OREGON PARKS & RECREATION DEPARTMENT  
5330 Seaman Road  
Oregon, Ohio 43616  
(419) 698-7145  
FAX (419) 698-7086

**ADDENDUM No. 1**  
**Recreation Buildings - 2023**

Plan holders of the Recreation Buildings - 2023 Project are hereby notified of the following amendments to the Contract Documents. The following additions, alterations, deletions and/or clarifications shall be part of the bid specifications as much as if they were originally included in the Contract Documents. This Addendum No. 1 is hereby made a part of the Contract Documents and must be receipted for on the proposal form.

MISCELLANEOUS PROJECTS  
FOR  
CITY OF OREGON  
RECREATIONAL DEPARTMENT  
GON,

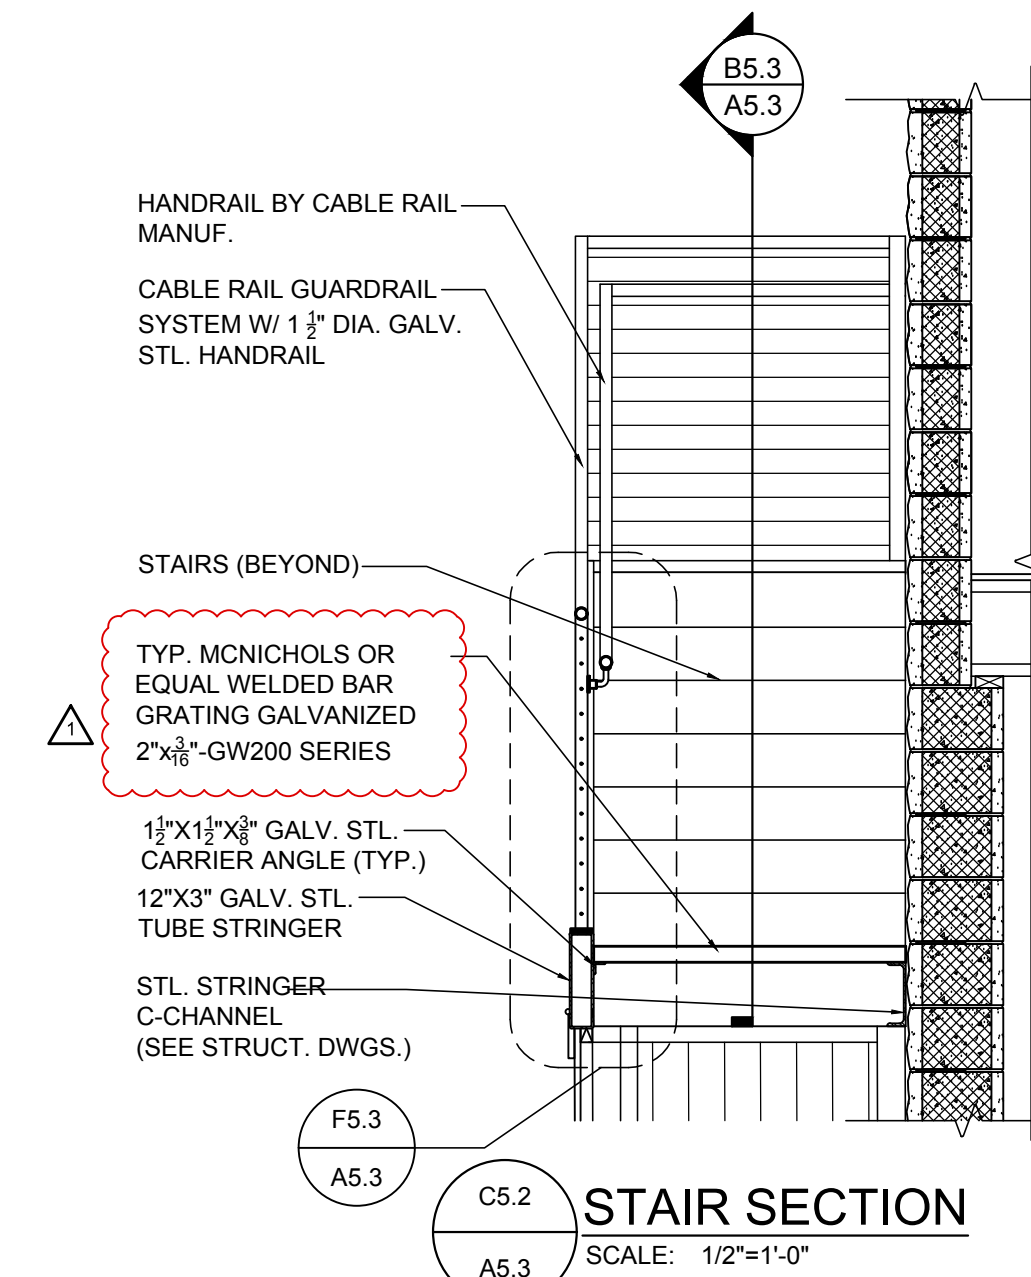
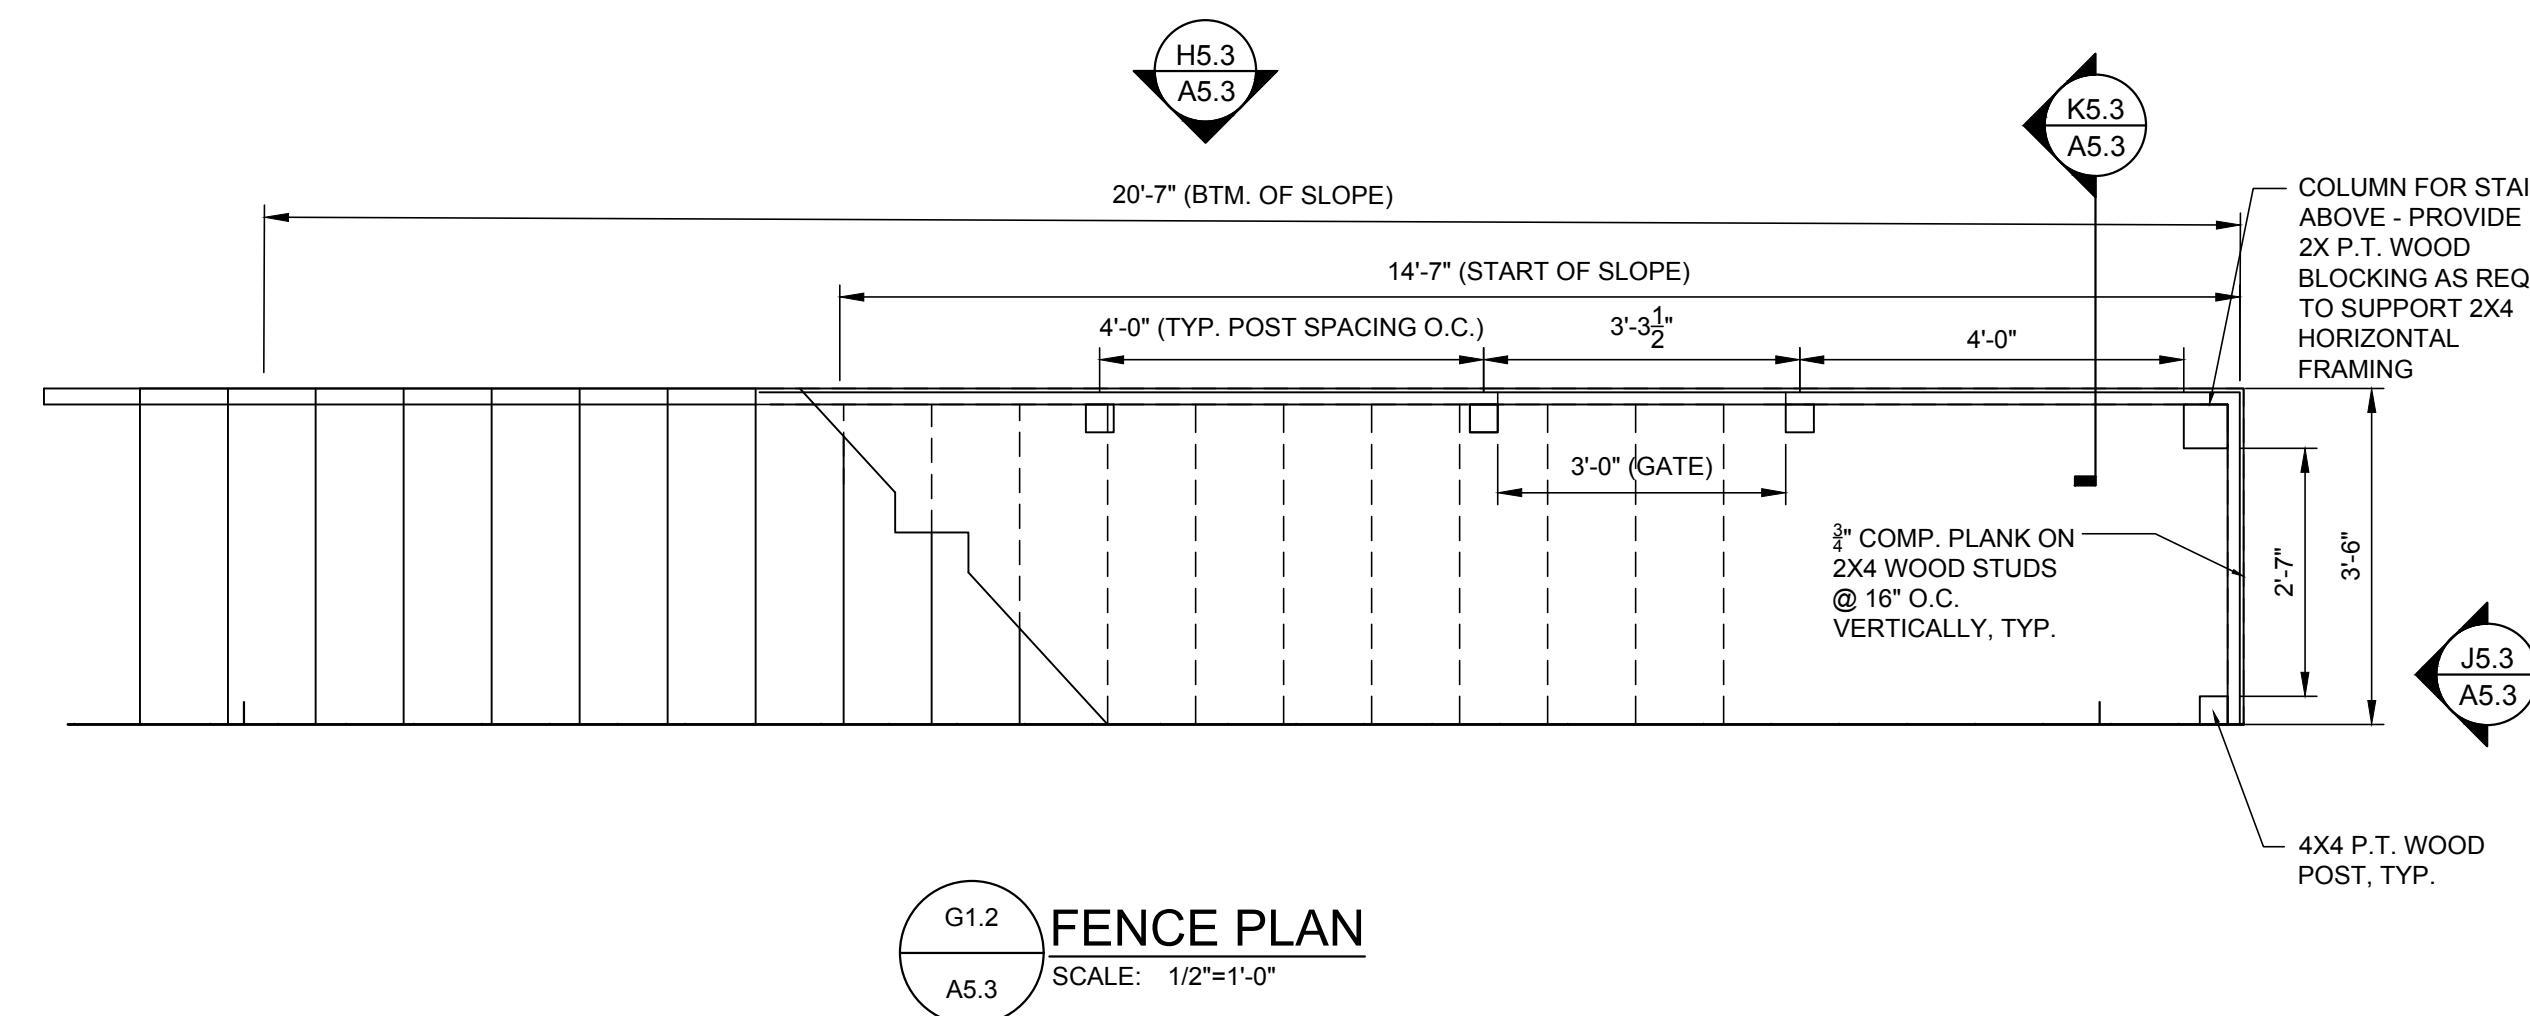
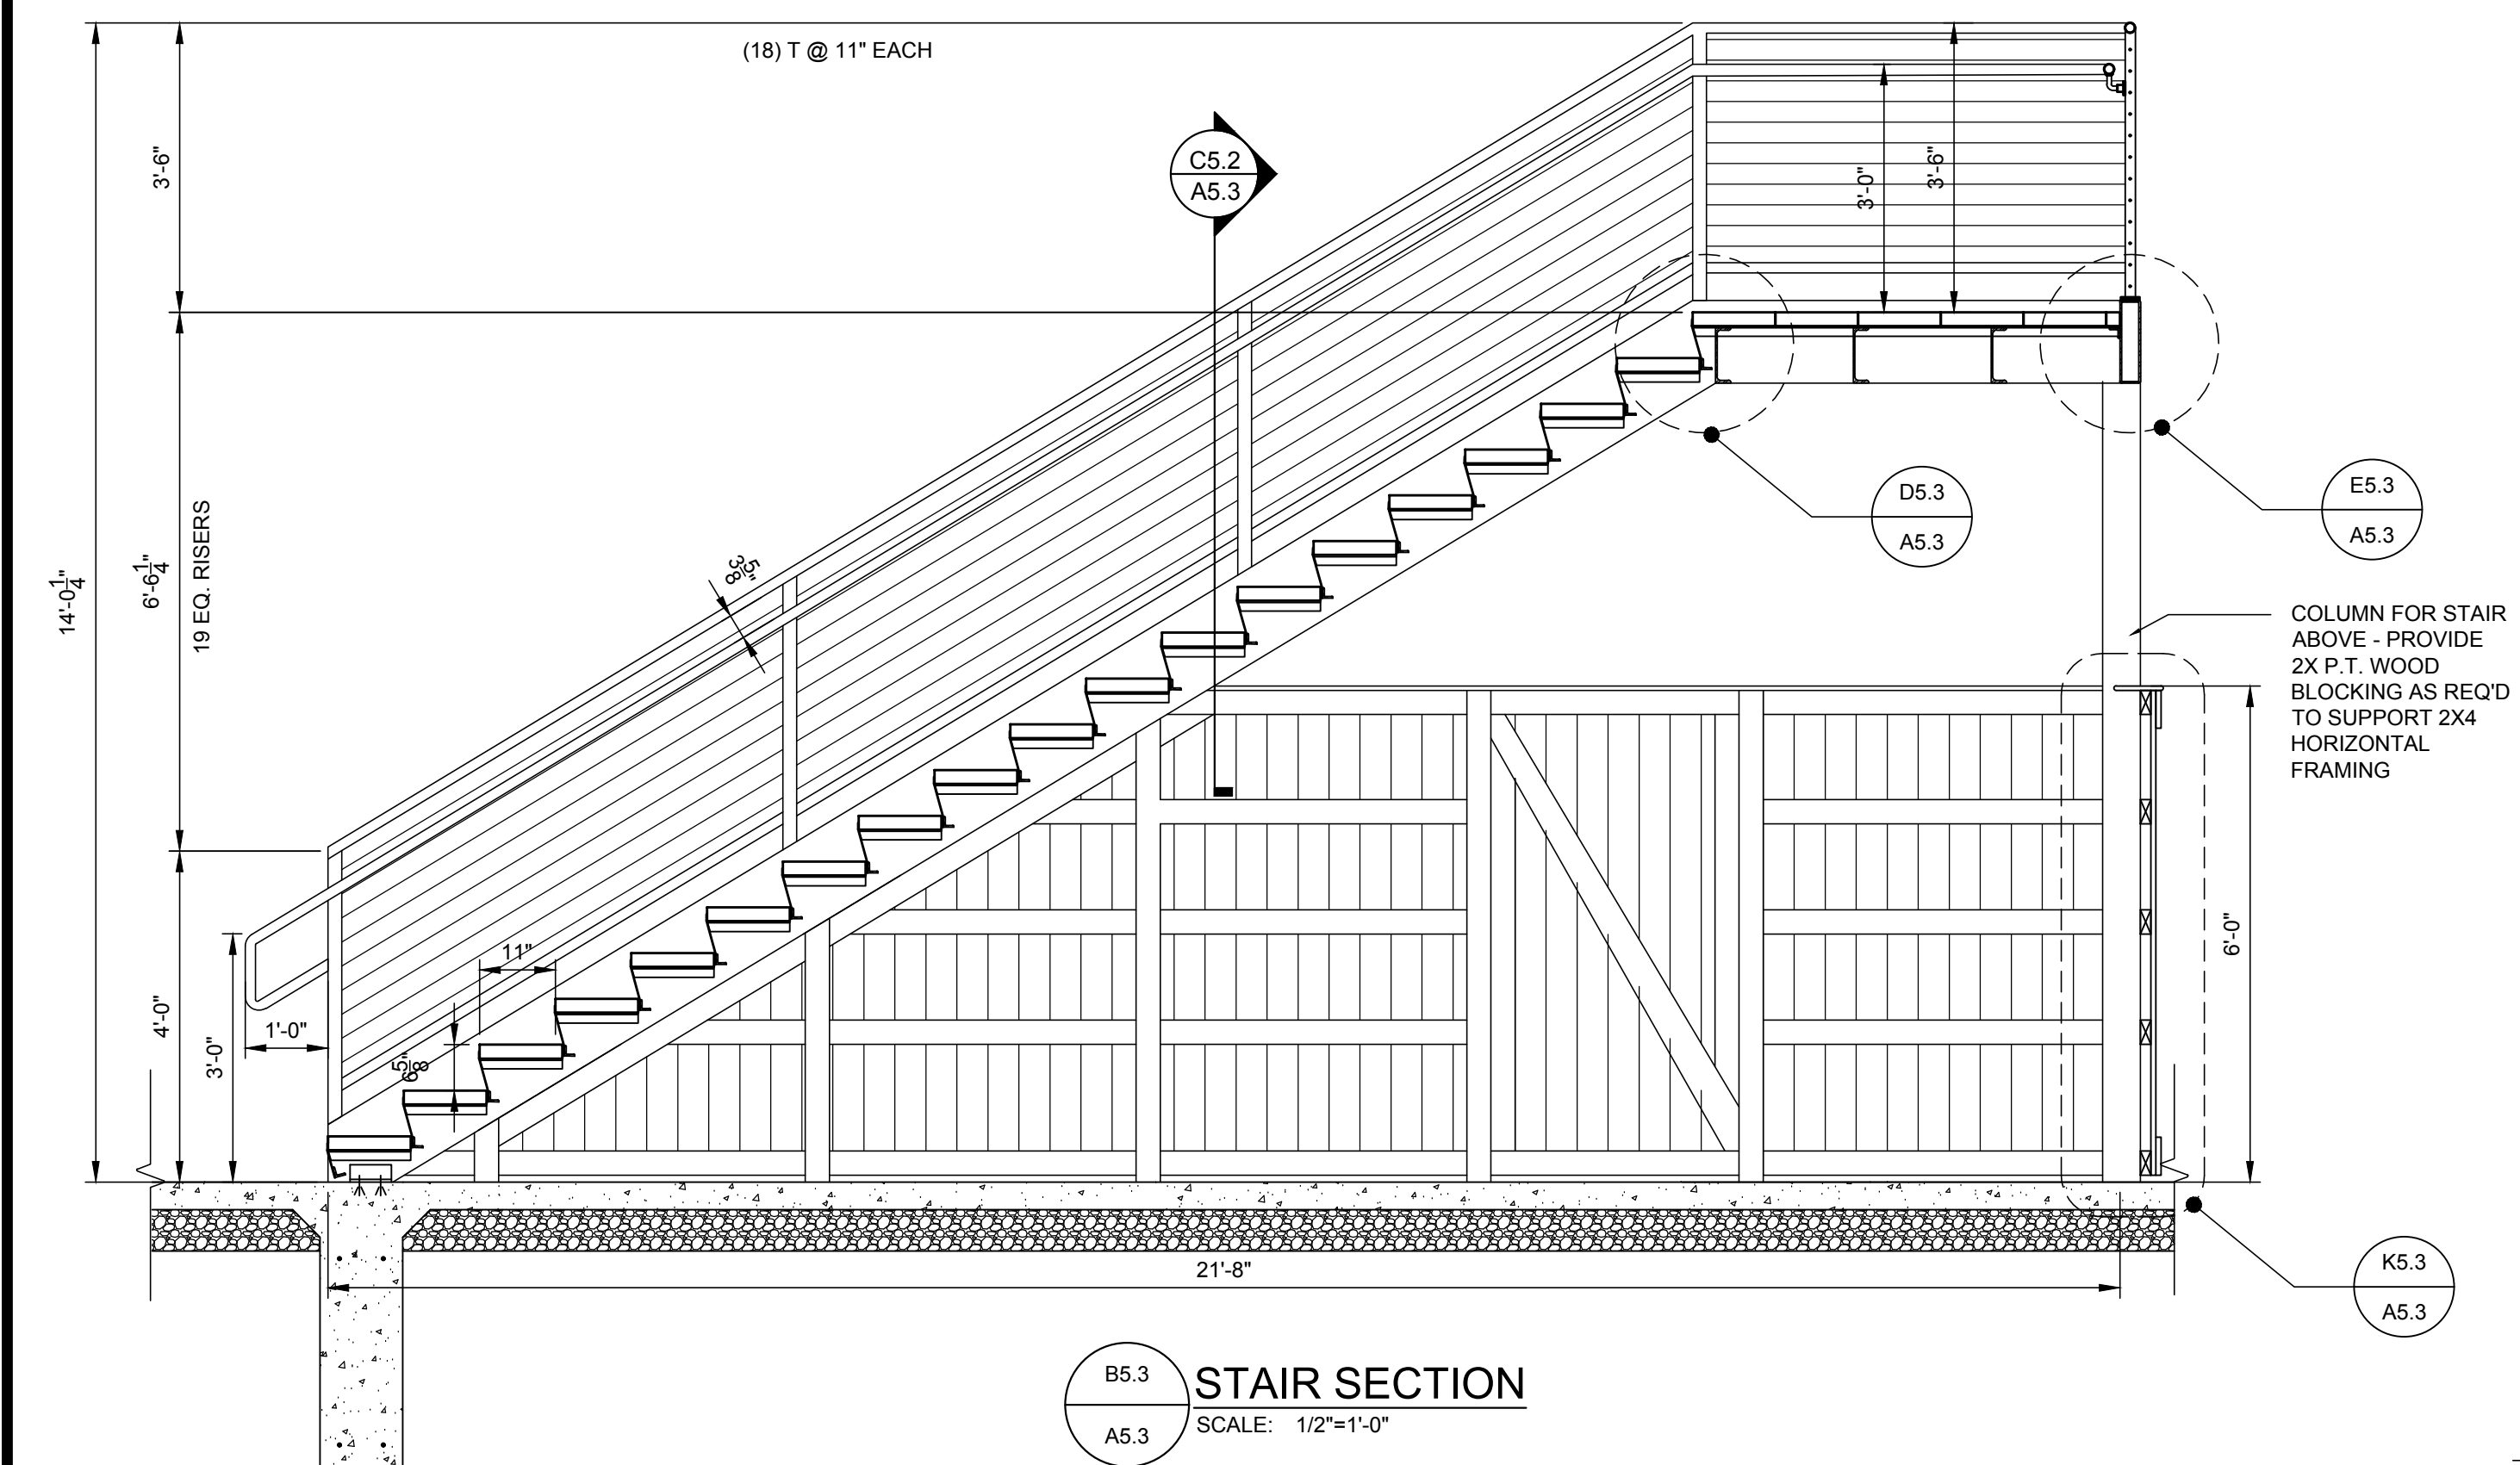
- 13) **Bidder Question:** *Regarding the stairs to the Pressbox: Drawing S2.2 calls for Welded Bar Grating as the walking surface, A5.3 calls for traction treads. Please confirm which is correct.*

- 14) **Bidder Question:** *Please provide additional details on the cable railing?*

**Architect/Engineer Response:** Welded bar grating is correct. Drawing A5.3 was corrected to match S2.2.

**Architect/Engineer Response:** New cable railing specification was added. Railing details can be found on sheet A5.3.
